HISTORIC AND DESIGN REVIEW COMMISSION February 17, 2021

HDRC CASE NO: 2021-037

ADDRESS: 830 DAWSON ST **LEGAL DESCRIPTION:** NCB 571 BLK 5 LOT 8

TYPE OF WORK: ADA ramp
APPLICATION RECEIVED: January 20, 2021

Patriot 830 dawson 29rise 29fee Ramp Plan and Elevations

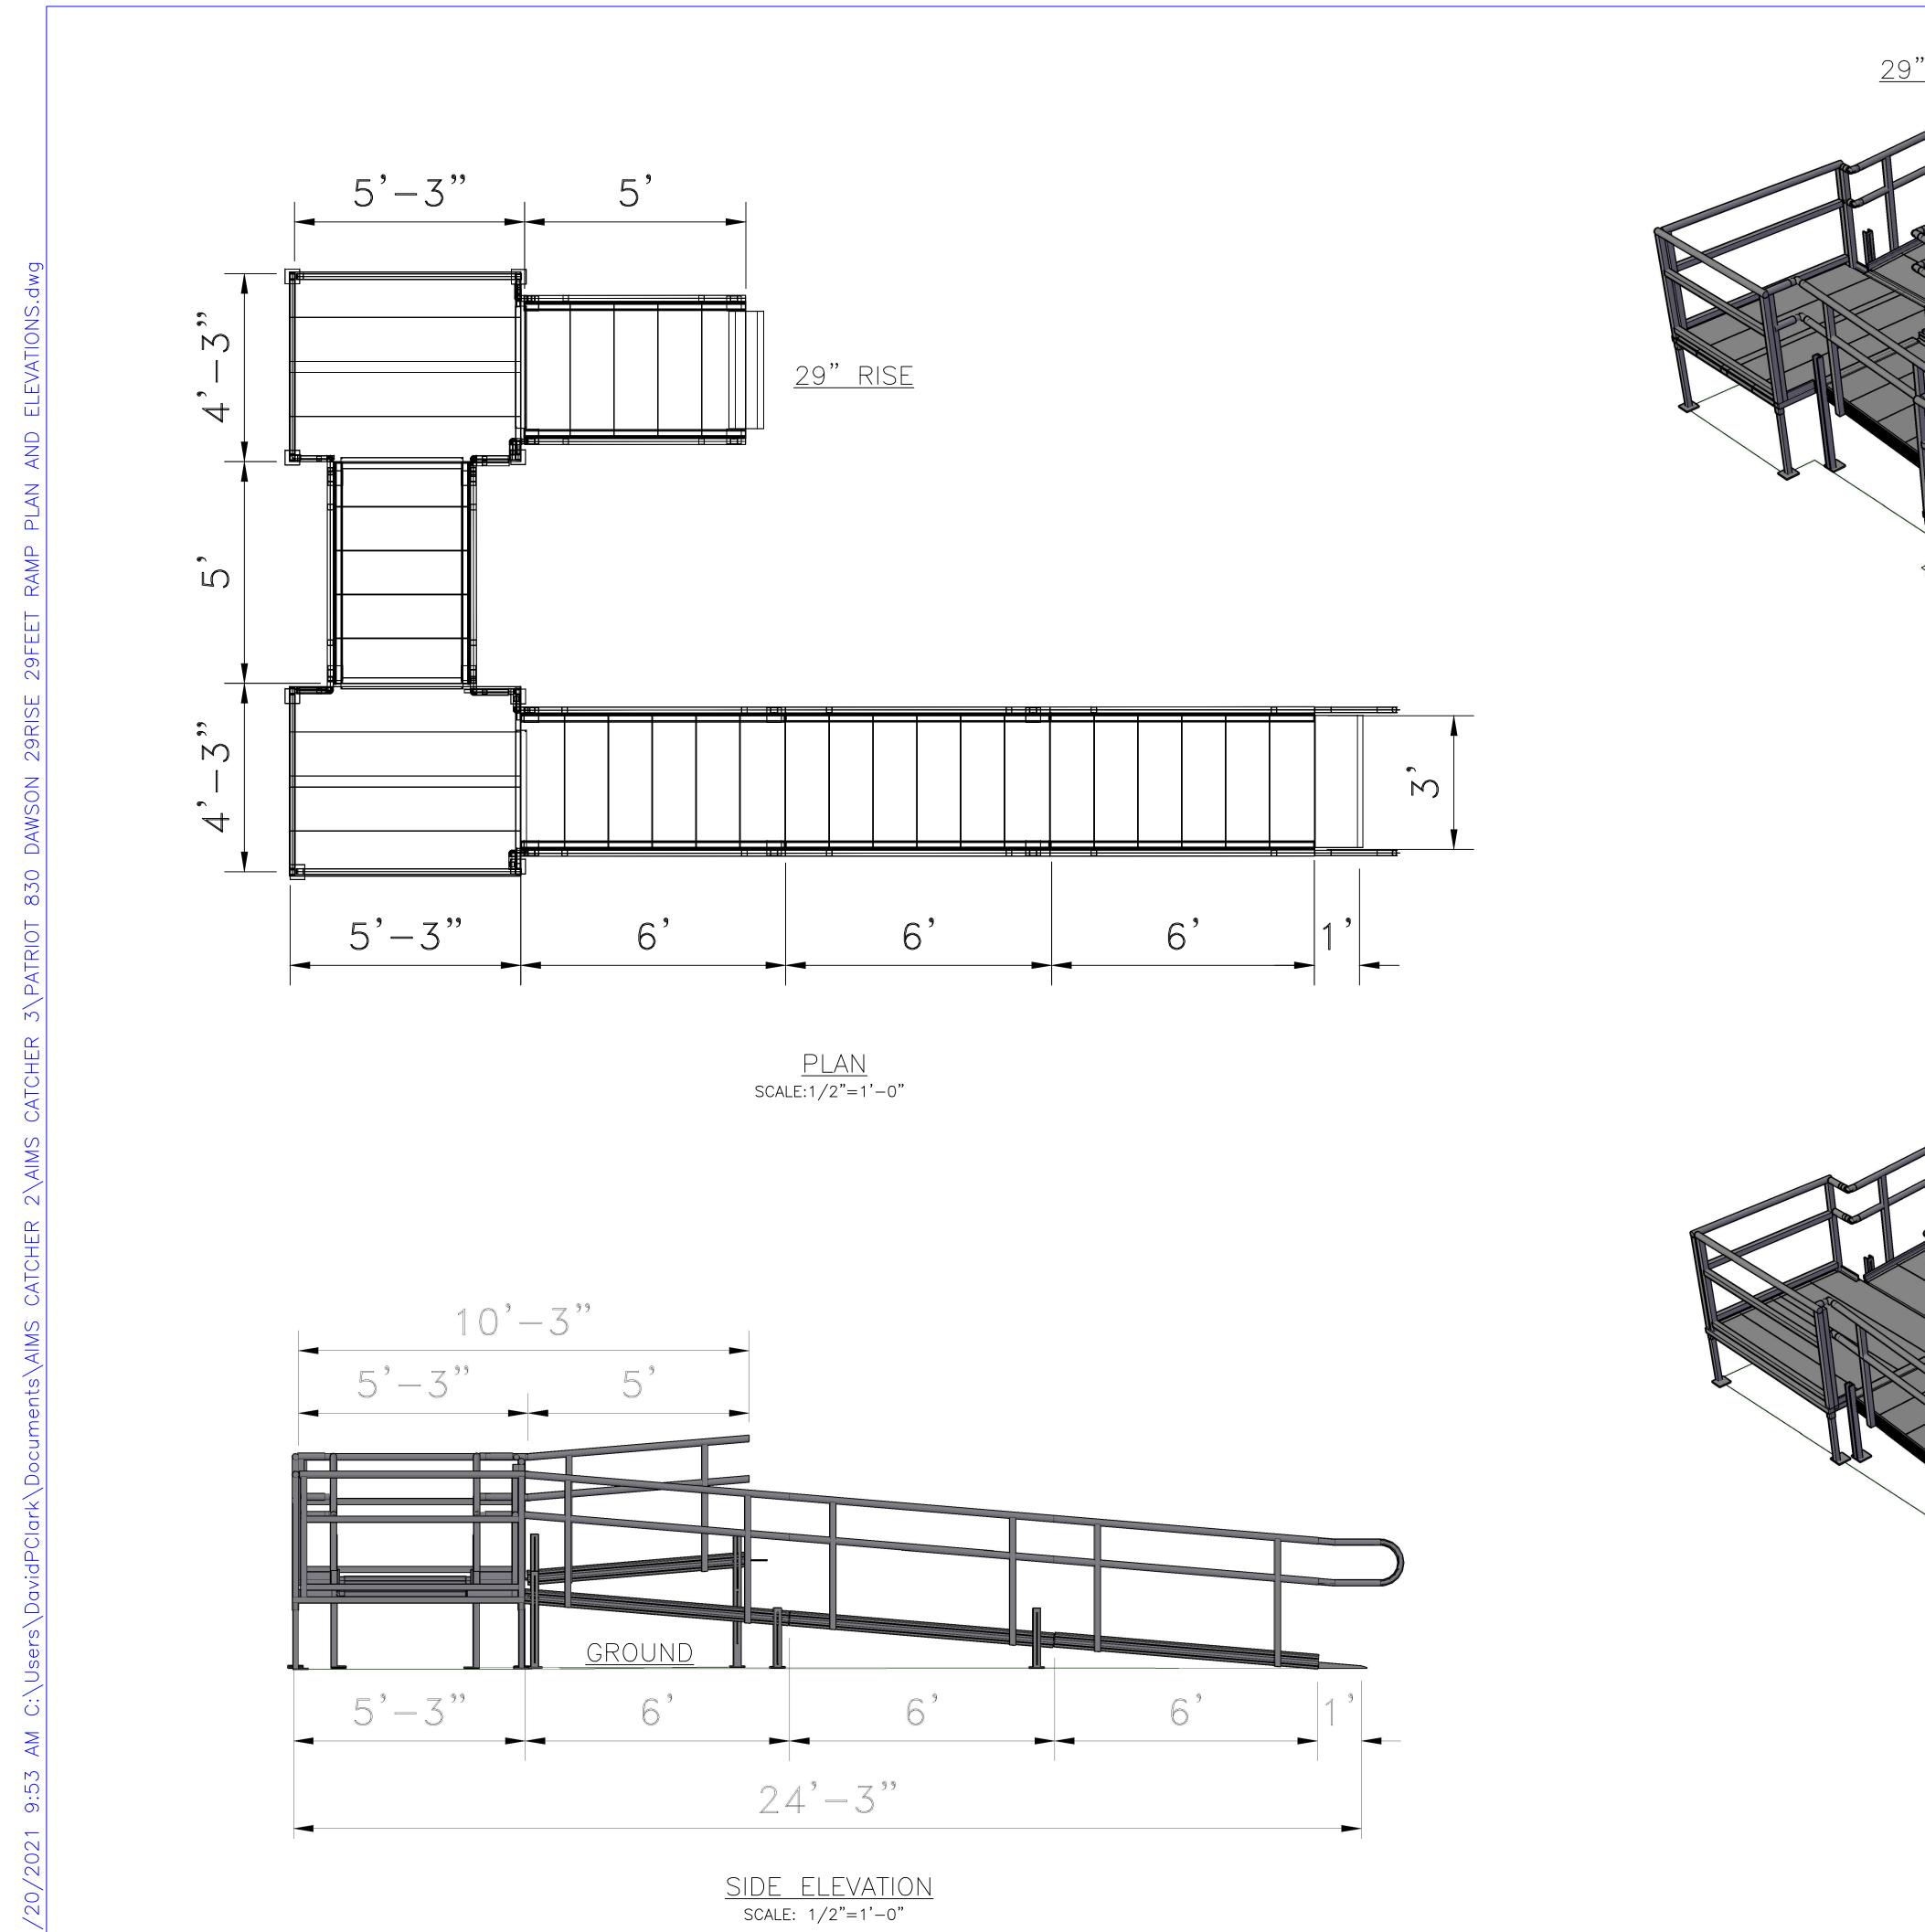
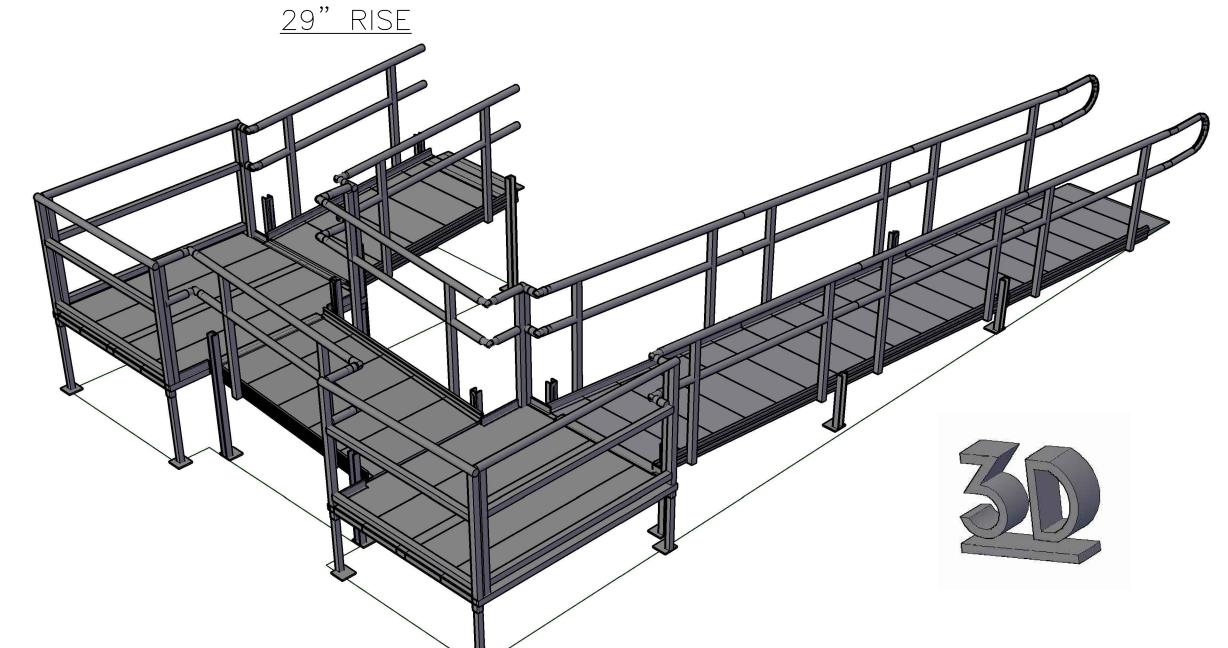
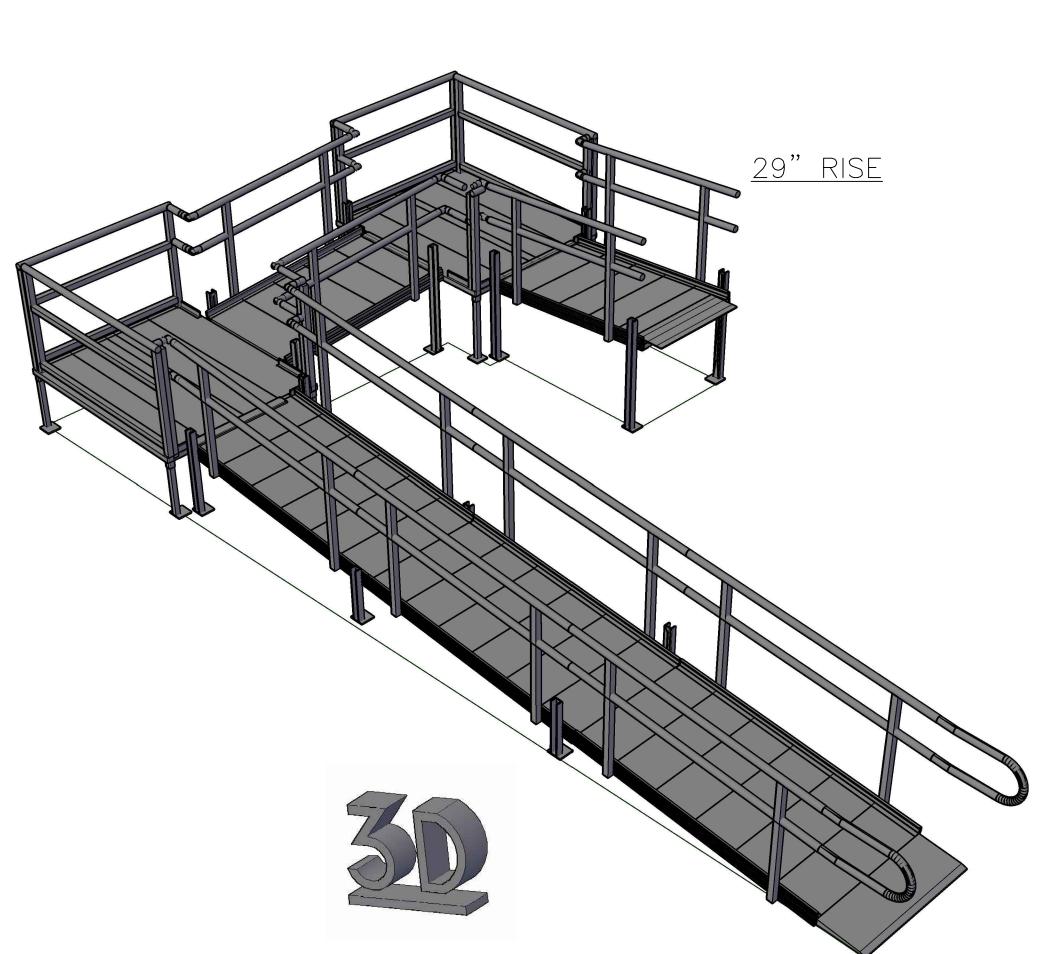
- c. LOCATION The applicant has proposed to install the ramp beginning at the east side of the porch and ending back at the centered walkway. Per the Guidelines for Exterior Maintenance and Alterations 8.B.ii., the preferred location for ramps on residential structures is on the side or rear of the structure when convenient for the user. Staff finds that the ramp entrance from grade should be oriented from the side yard as it approaches the front or

- rear porch, rather than in the front lawn as proposed.
- d. DESIGN The applicant has proposed a ramp design that feature metal construction with three 3-foot wide slopes and two 4-by-5-feet landings for turning. Per the Guidelines for Site Elements 8.C.i., applicants should design ramps and lifts to compliment the historic character of the building and be visually unobtrusive as to minimize the visual impact, especially when visible from the public right-of-way. Staff finds that the metal provides contrast to the historic structure and should instead feature wood construction.

- e. SCREENING Per the Guidelines for Site Elements 8.C.ii., applicants should screen ramps, lifts, or other elements related to ADA compliance using appropriate landscape materials. Staff finds that the installation of additional landscaping items would further screen the proposed ramp.

- i. That the ramp entrance from grade should be oriented from the side yard as it approaches the front or rear porch, rather than in the front lawn as proposed.
- ii. That ramp should feature wood construction instead of metal. An updated design should be submitted to staff for review and approval prior to installation.
- iii. That additional natural landscape features be considered for additional screening in the front yard.
- iv. That when no longer needed by the current residents, the ramp can be removed and the historic structure can be returned to its previous configuration.
